UNITED STATES OF AMERICA
NUCLEAR REGULATORY COMMISSION

In the Matter of)
)
LONG ISLAND LIGHTING COMPANY) Docket No. 50-322-OL-3
) (Emergency Planning)
(Shoreham Nuclear Power Station,)
)
Unit 1))
)

SURREBUTTAL TESTIMONY OF DAVID T. HARTGEN, Ph.D., P.E.,
ON BEHALF OF THE STATE OF NEW YORK REGARDING
HOSPITAL EVACUATION TIME ESTIMATES

TRACE OF
HILCO REVISED
HOSPITAL EVAC.
PATH

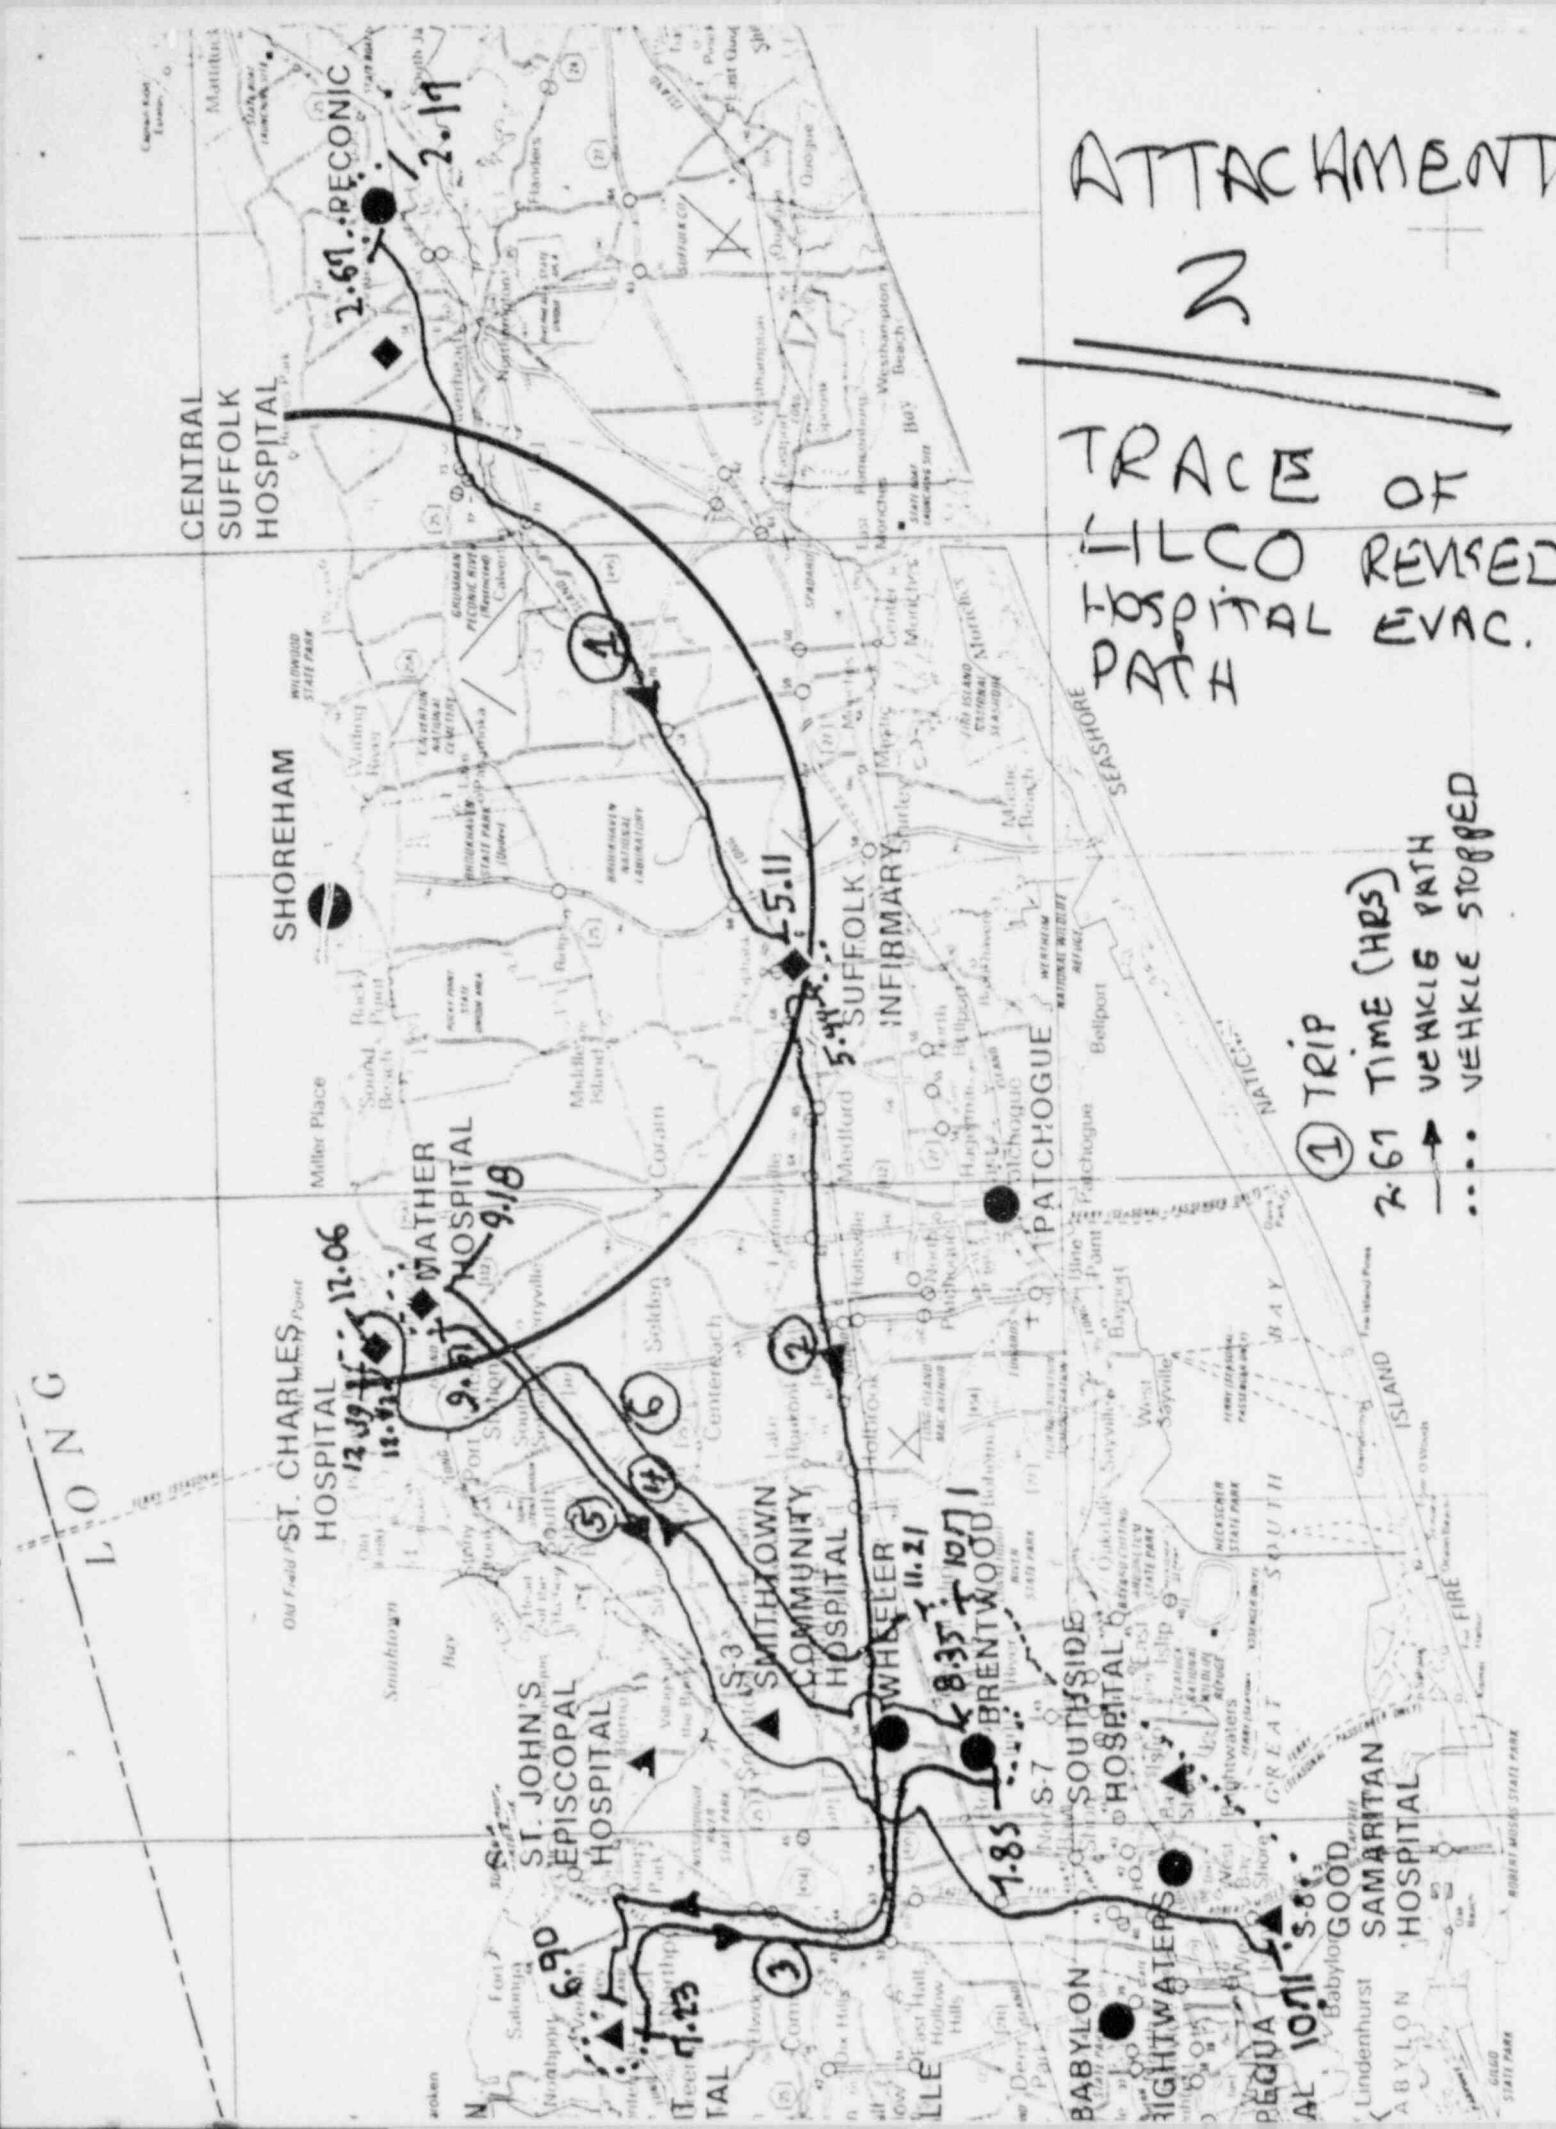
3. A particularly serious problem is the apparent assignment of some vehicles to be at two locations at the same time. For instance, page 4 of Table 1 of LILCO's Rebuttal Testimony (Attachment 1 hereto) shows that the two ambulances involved in the trace left Brentwood at hr. 11.21 for the final run to St. Charles Hospital (noted as trips 46 and 45 on page 4 of Table 1). These vehicles arrived at Brentwood at 10.71, from trips #10 and #8. However, on p. 2 of Table 1, trips #10 and #8 are shown as arriving at Good Samaritan Hospital at 10.71. Therefore, the printout shows that the vehicles are in two places at the same time. This is also shown in Attachment 2 hereto, which is a drawing of the vehicles' movements. The discrepancy is shown as an identical time (10.71) at Brentwood and Good Samaritan.

There are at least three possible explanations for this phenomenon:

- a. Page 2 of Table 1 is wrong, and the vehicles are actually at Brentwood at 10.71. If this is the case, the patients are also at Brentwood, and must be transported to a reception hospital. So, the trips between this reception

hospital and Brentwood are missing. This causes an error of at least 1 hour (the round-trip distance from Good Samaritan to Brentwood is about 14 miles) in the trace, and possibly in all other trips as well. In other words, the evacuation time is low by about an hour.

- b. Page 4 of Table 1 is wrong, and the vehicles are at Good Samaritan at 10.71, but then are dispatched directly from there to St. Charles. This explanation is consistent with the note on the bottom of the third page of Attachment 1 hereto (that Good Samaritan is now considered a dispatch point). But, if Good Samaritan is a dispatch point, the trip from Good Samaritan to St. Charles takes 0.85 hrs (12.06-11.21) according to page 4 of Table 1, or only 0.05 hours longer than the trip from Brentwood to St. Charles according to the handwritten calculations. Since Good Samaritan, Brentwood, and St. Charles are essentially on a straight line, (see Attachment 2 hereto) this means that a trip of 7 miles is accomplished in 0.05 hours, or 3 minutes. This requires a speed of 140 mph.

c. Page 2 of Table 1 is correct. The vehicles are at Good Samaritan at 10.71 and are dispatched directly to St. Charles, but in bypassing Brentwood they save 0.33 hours reprocessing time, so the trip to St. Charles is 1.35 hours (12.06 - 10.71), according to page 4 of Table 1. If this is the case, then the unload time at Good Samaritan is missing, and page 4 of Table 1 is incorrect.

Whichever of these explanations is the correct one, it casts extreme doubt on the accuracy of this latest LILCO model. Since numbers on the trace appear to be incorrect, the other numbers cannot be trusted.
